Addendum 2

RFQMA24 – 5030

Glenforest Secondary School City of Mississauga

Pool Demolition

A101

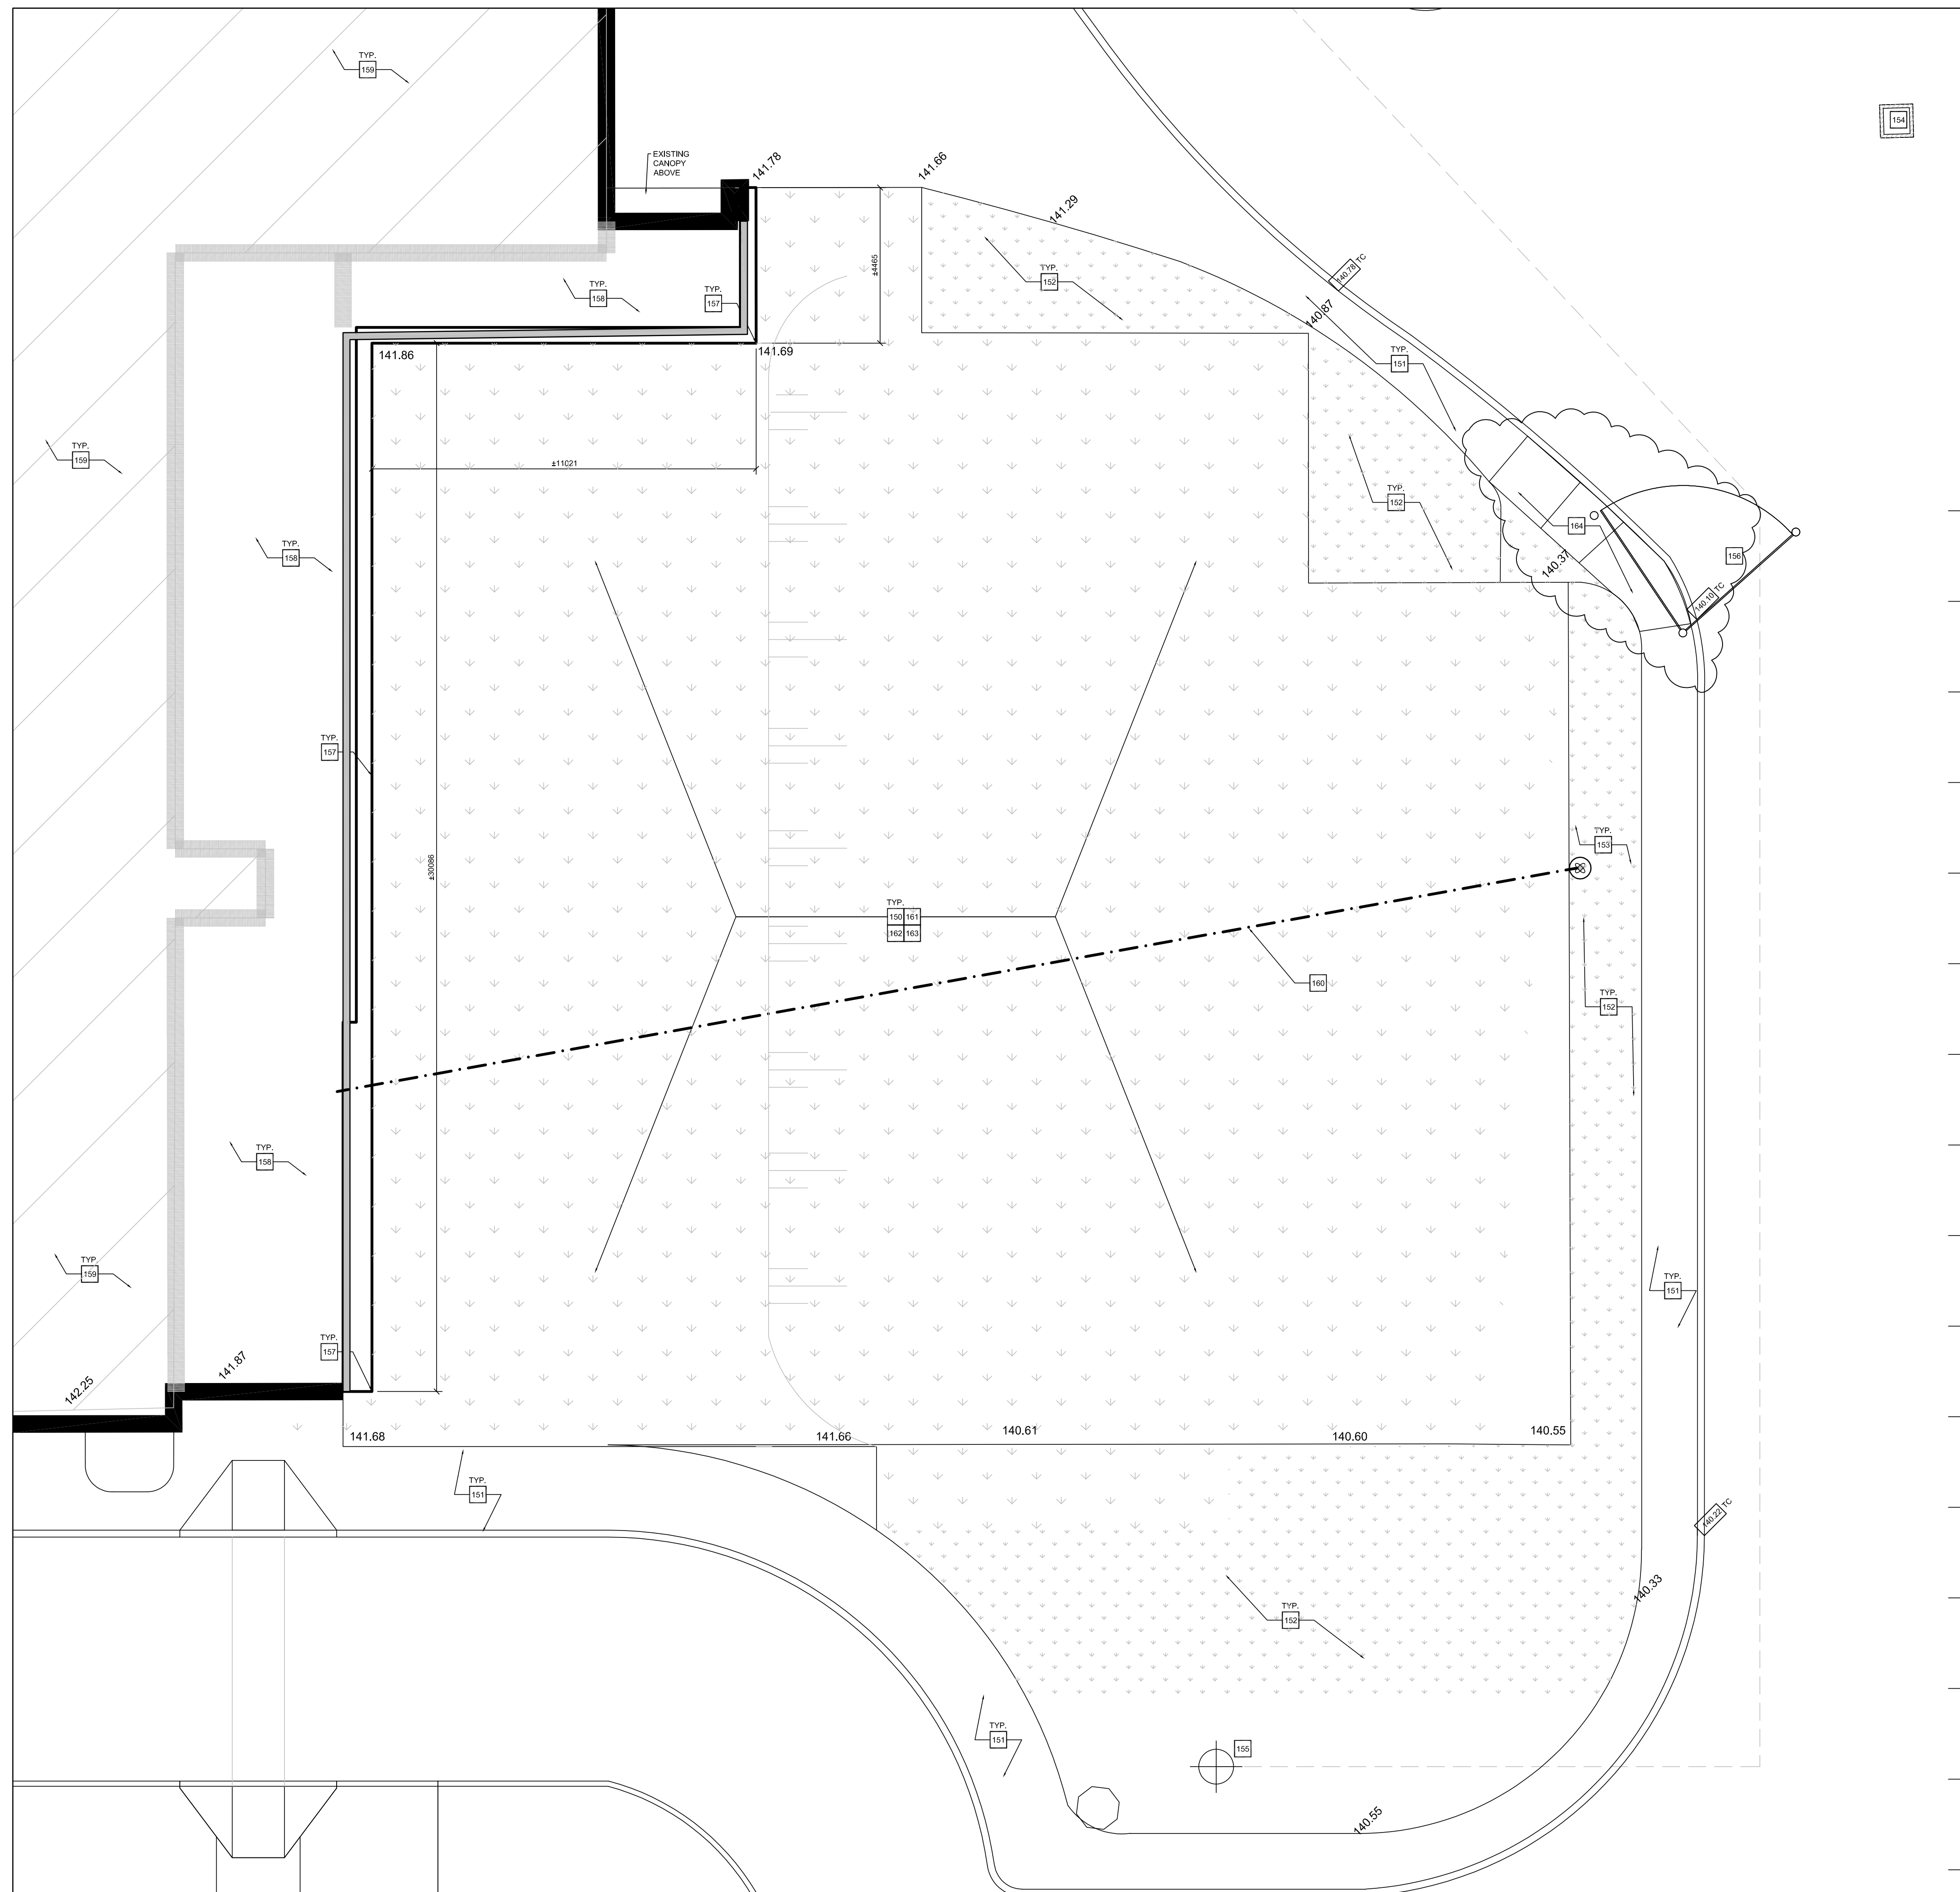
- 2.3.1. Refer to Electrical Addendum no. M&E#1
- 2.4. Demolish three (3) conc. sidewalk sections and provide new conc. sidewalk. Reinstate depressed curb. See note 118 on drawing A101, and note 164 on drawing A102.

Graphic Scale AS SHOWN		Sheet no.
Drawn AK / VSP	Checked AM	A202
CAD File AS NOTED	Scale AS NOTED	
Date DECEMBER 2022	Project No. 222113	Revision No.

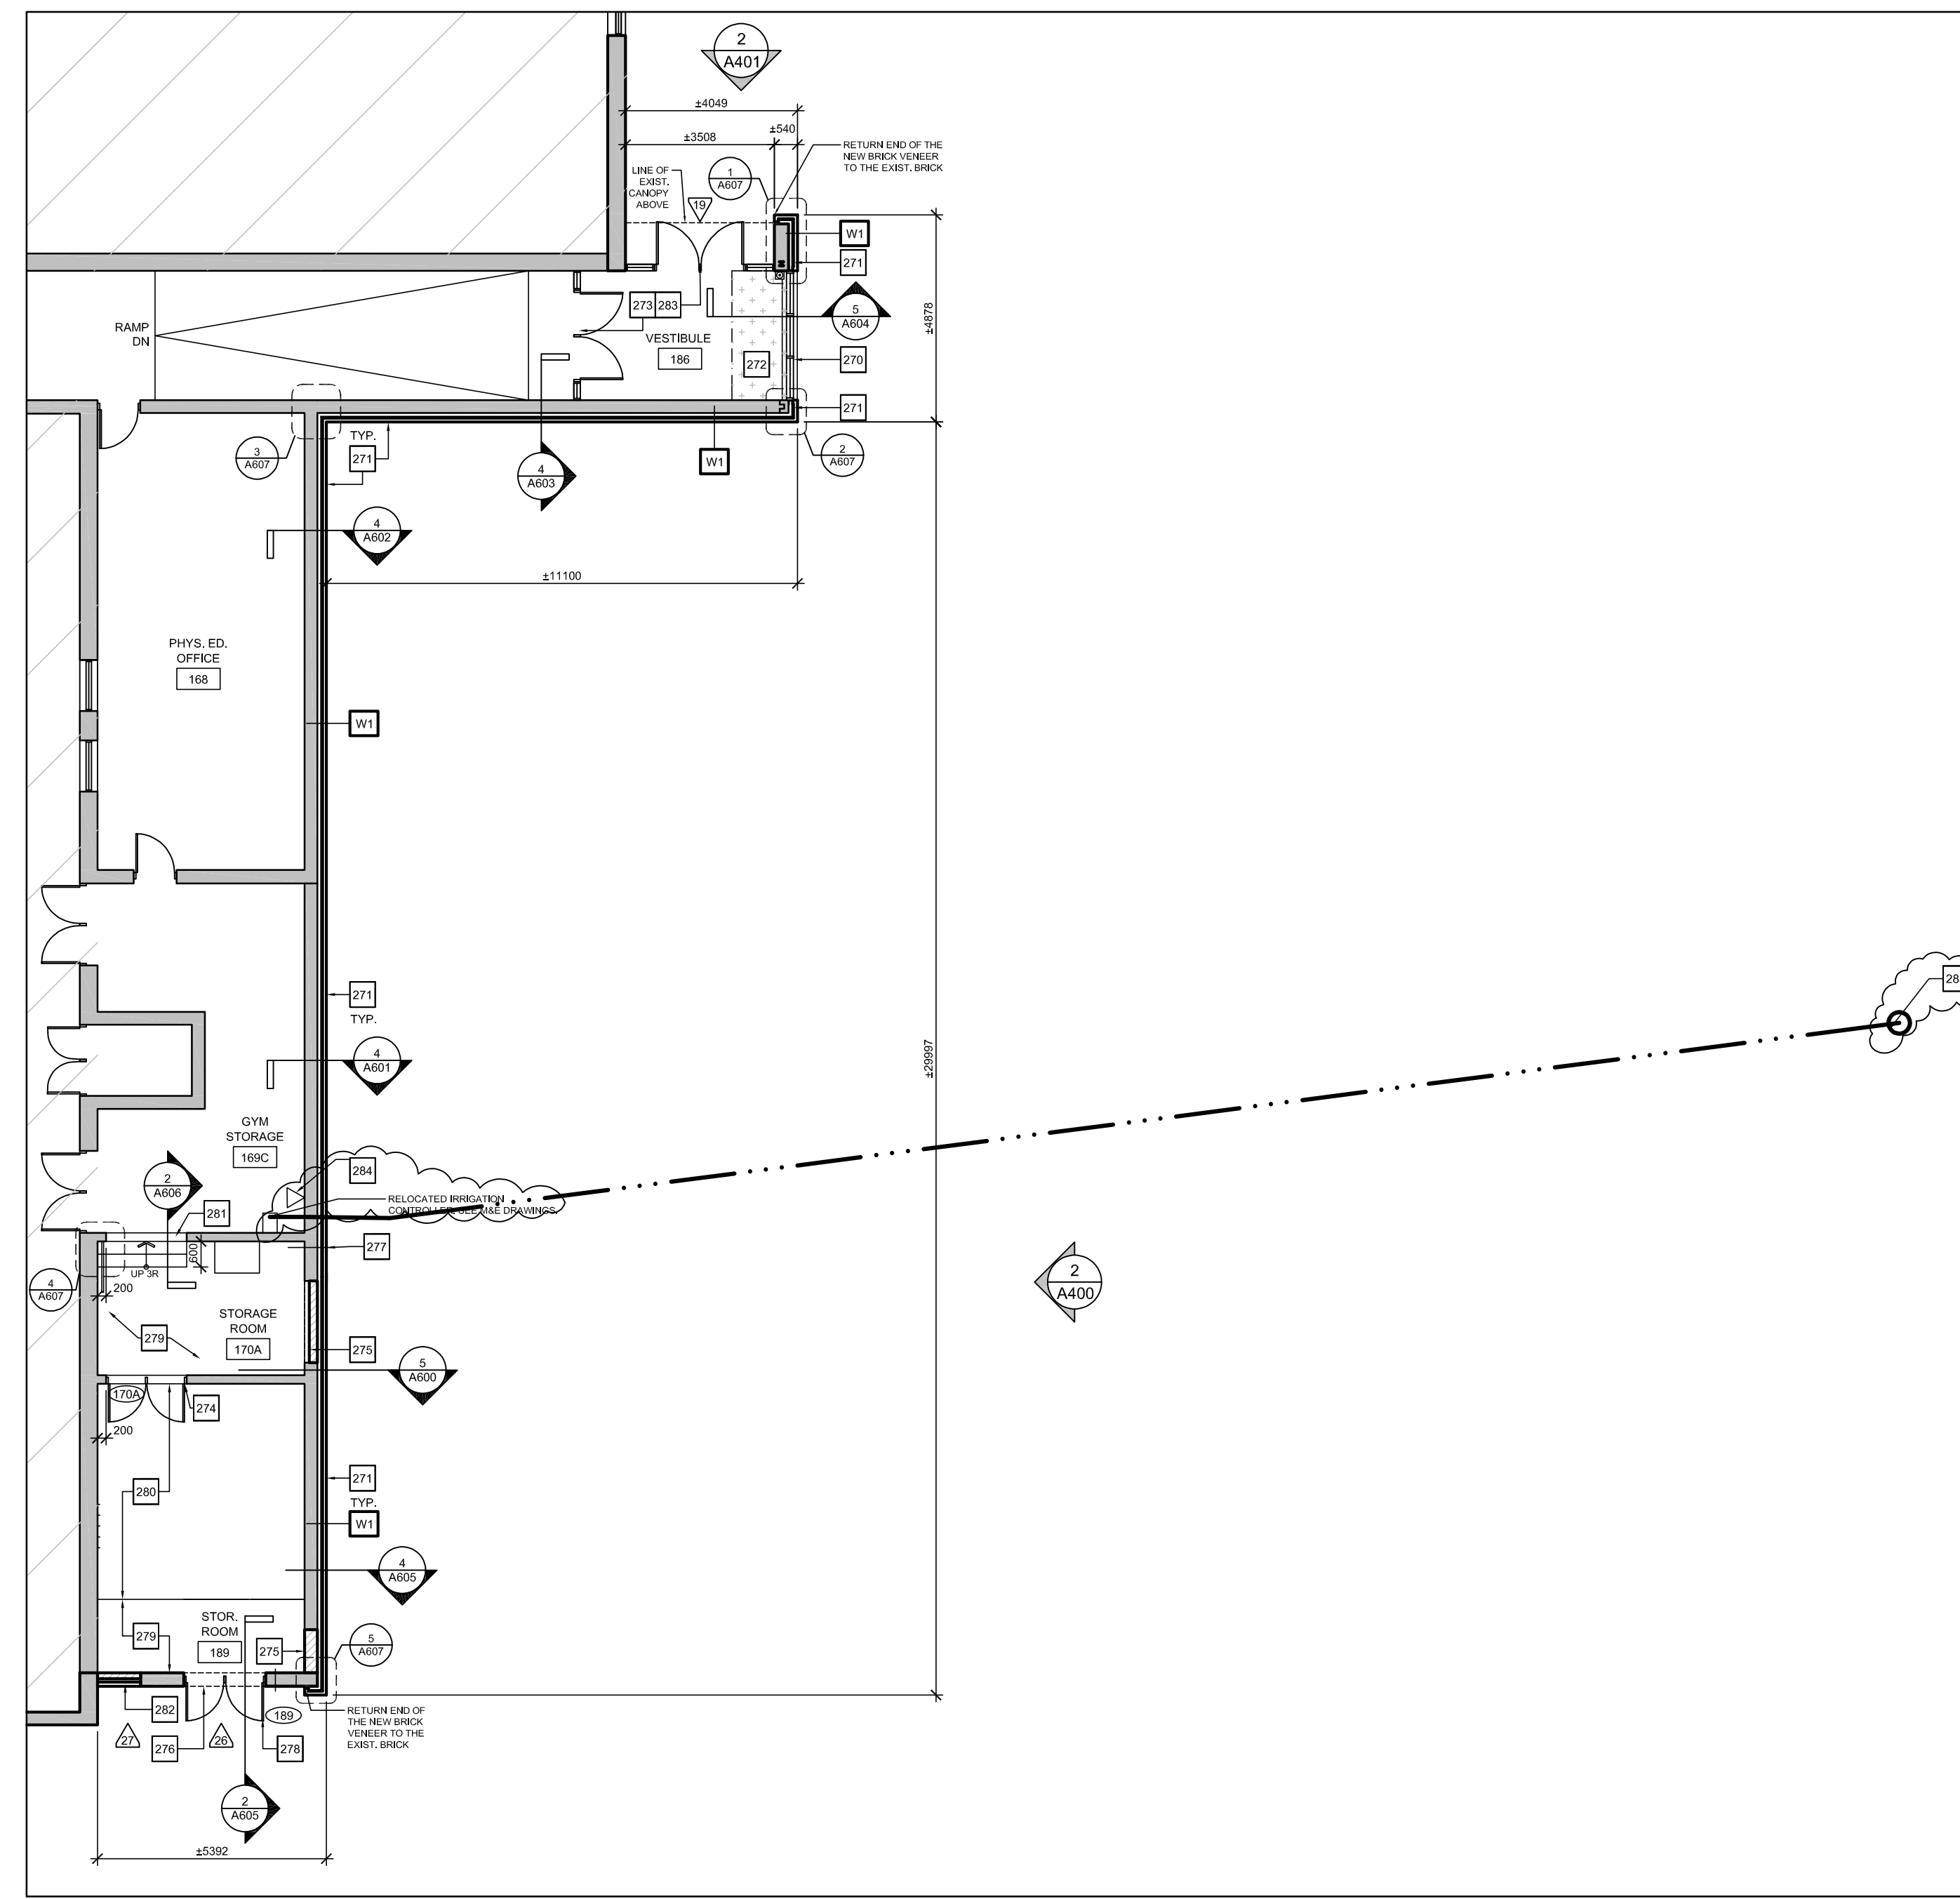
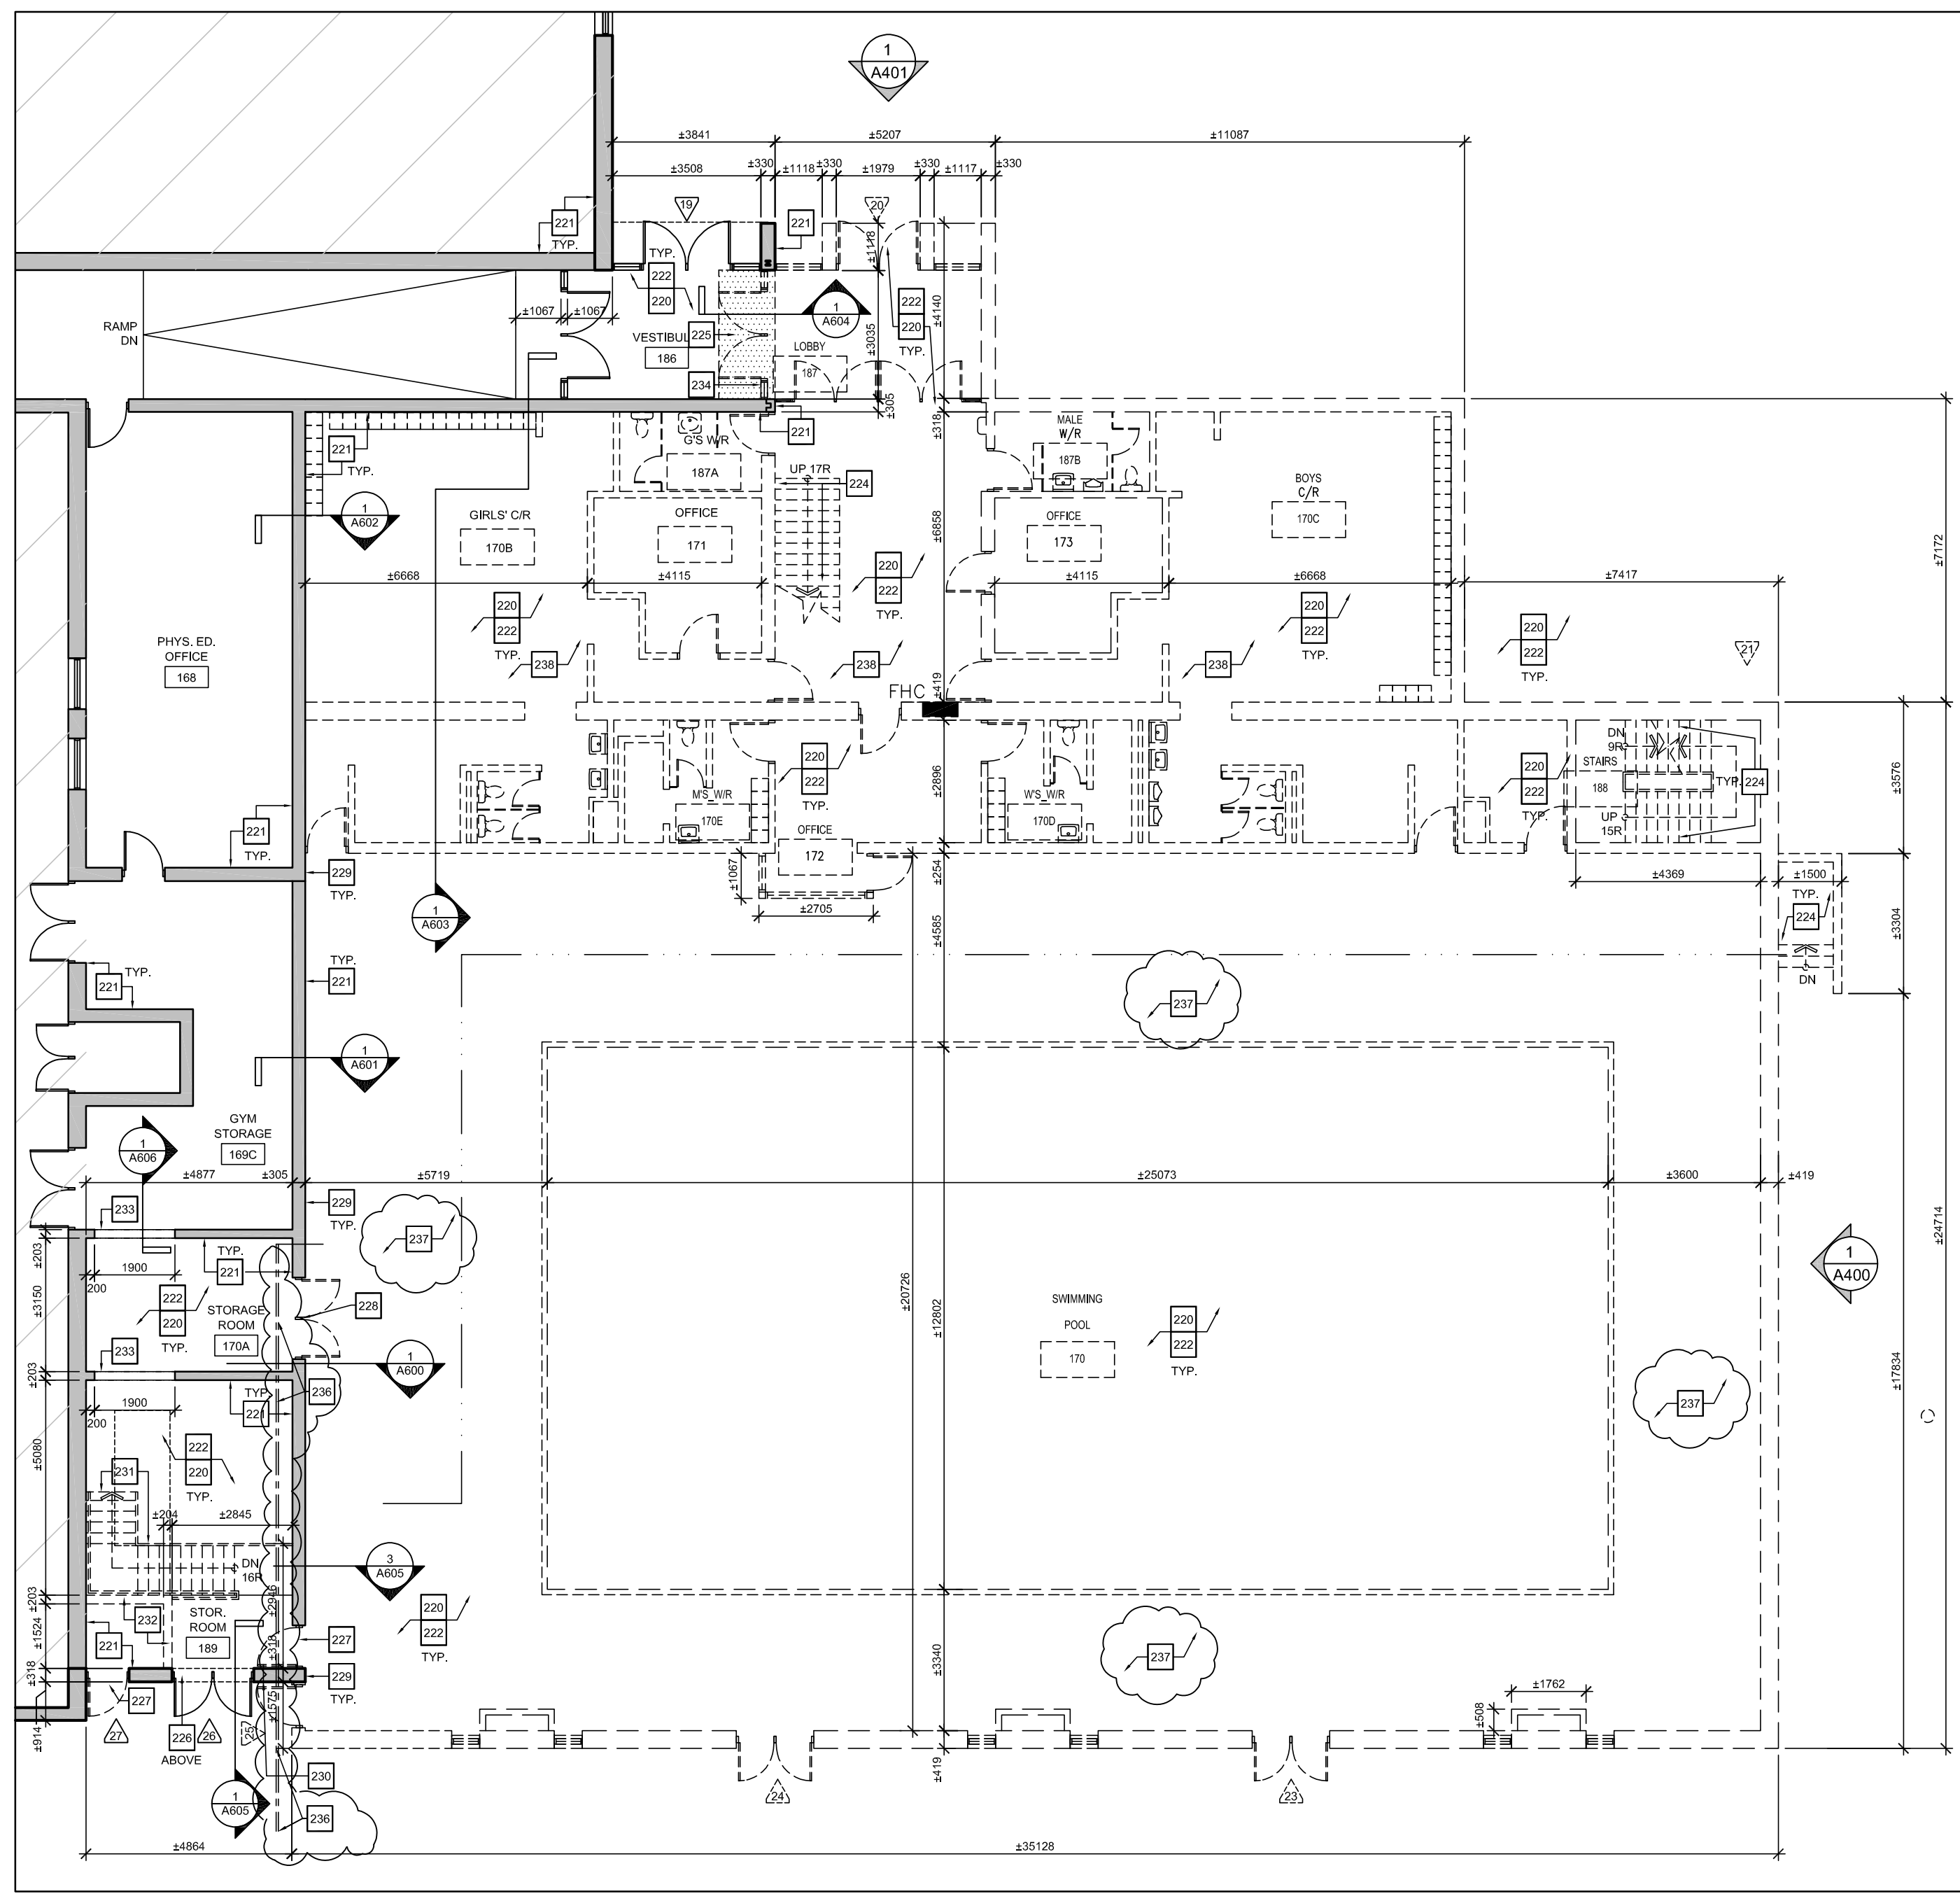
- 2.2.1. Refer to Mechanical Addendum no. M&E#1
- 2.3. Refer to note 4 on E5. GC to provide routing for conduit and wiring for relocated GFI Outlet. Location of outlet to be relocated to gym storage room. Exact location to be determined on site. See note 215 on A201, and note 284 on A202. Trace wire to panel, and refeed from panel.

- 2.5. Clarification: Additional notes 214 and 237 added to demolition floor plans A201 and A202, regarding thickness of floor slabs.

- 2.8. Refer to revised note 235 on demolition plan. Break up and remove slab on grade.
- 2.9. Base building BAS contractor is: Johnson Controls
- 2.10. Question 1:
